November 9, 2018

This letter represents the comments of the Sierra Club Loma Prieta, the Santa Clara Valley Audubon Society, and the Committee for Green Foothills with regard to the Tasman East Focus Area Specific Plan.

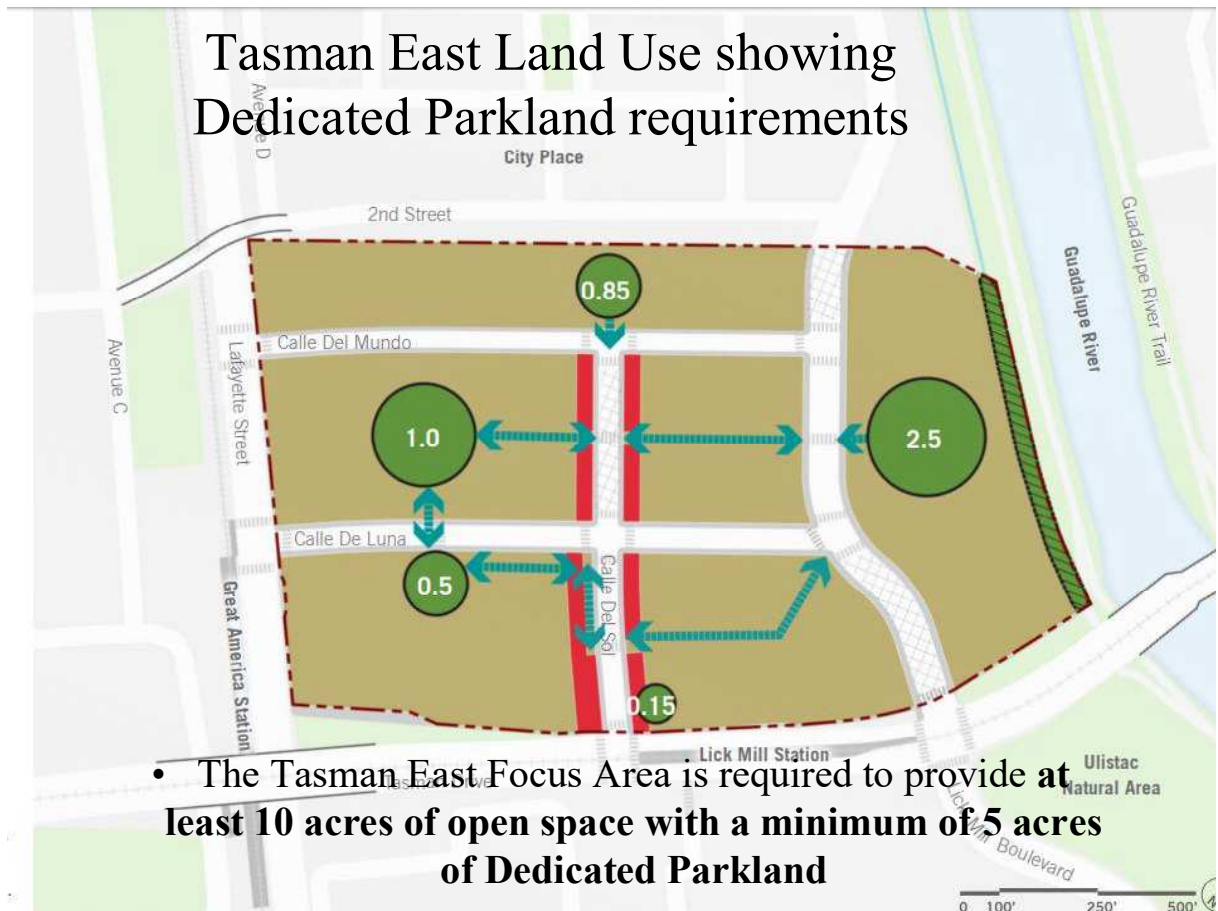
However, the Specific Plan is missing the guidelines that state how this goal is to be achieved. Therefore we request the following change to clarify intent:

<sup>1</sup> The photograph of water slides on page 70 should be removed, as it is incompatible with the concept of a passive recreation area.

1. The park in the river District shall ~~maintain public access along the waterfront and be~~ designed to embrace the Guadalupe river as a central feature and provide a park along the riverfront for open space, increasing tree cover creating connectivity and contiguous habitat to Ulistac Natural Area for migratory birds, butterflies and pollinators
2. The park ~~may also provide a public outdoor amphitheater that can host concerts, movies, and other public events~~ shall provide for passive recreation in recognition of the proximity of sensitive wildlife habitat.<sup>1</sup>

# Tasman East Phase One

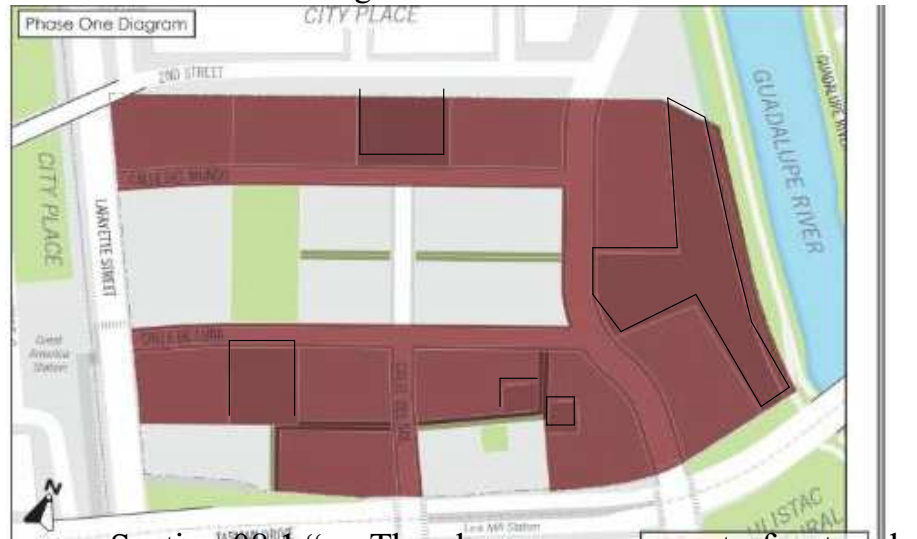
Conceptual Open Space shown in dark red  
Section 07.2 Phasing and Thresholds & in the EIR

- Section 08.1 “...The plan proposes a waterfront park that would provide access to the river and increase tree cover, creating contiguous habitat for migratory birds, butterflies, and other pollinators”

**SITE DIAGRAM OF RIVER DISTRICT SHOWING SETBACKS**

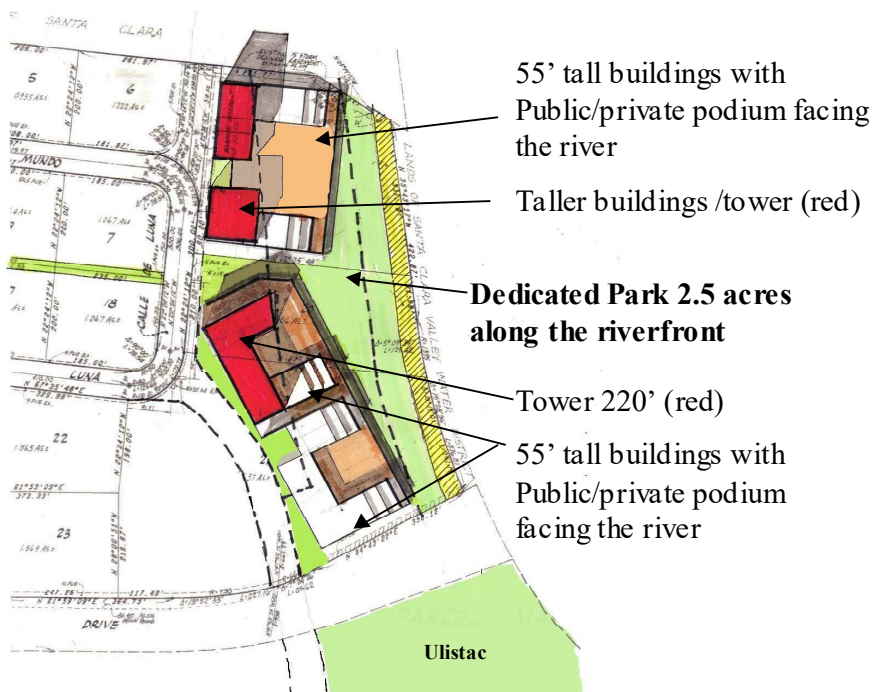
**We request that the following wording be included in the Specific Plan:**

M. All buildings and hardscape shall be set 100’ back from the top of bank along the Guadalupe River.

**A DIAGRAM OF RIVER DISTRICT – SHOWING RIVERFRONT PARK WITH 55' TALL BUILDINGS AND POTENTIAL TOWER LOCATIONS**

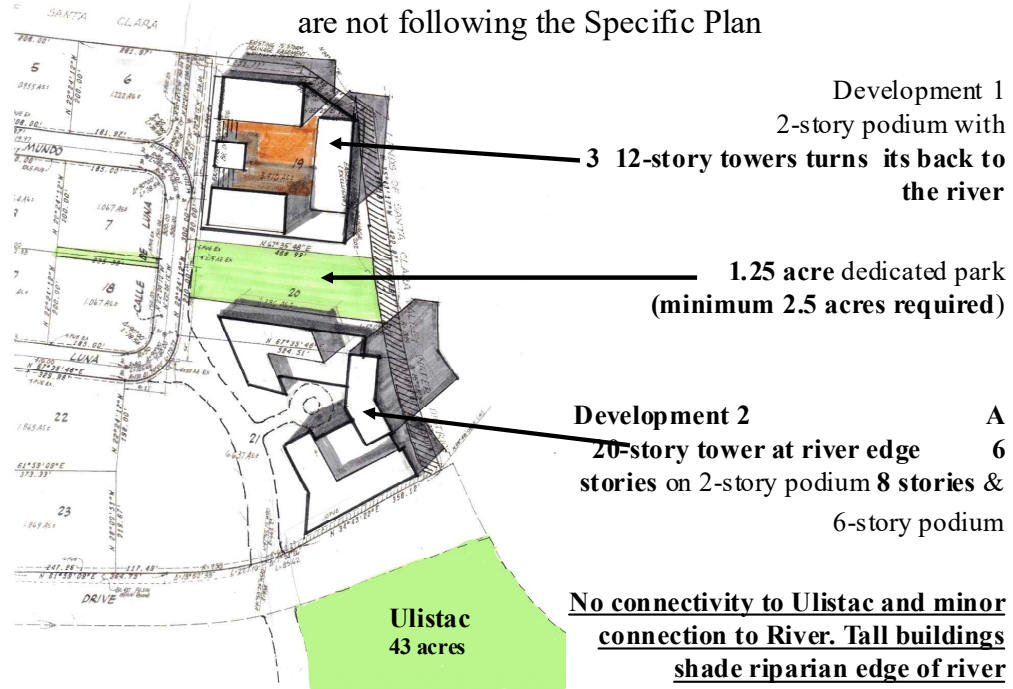
**We request that the following wording for a height restriction zone, along the river and Ulistac, be included to protect bird life along the migratory flyway and Ulistac:**

N. No buildings taller than 55' shall be constructed within 300 feet of the top of bank along the Guadalupe River or the Ulistac Natural Area habitat. Beyond this, taller buildings shall be allowed with bird-friendly design.
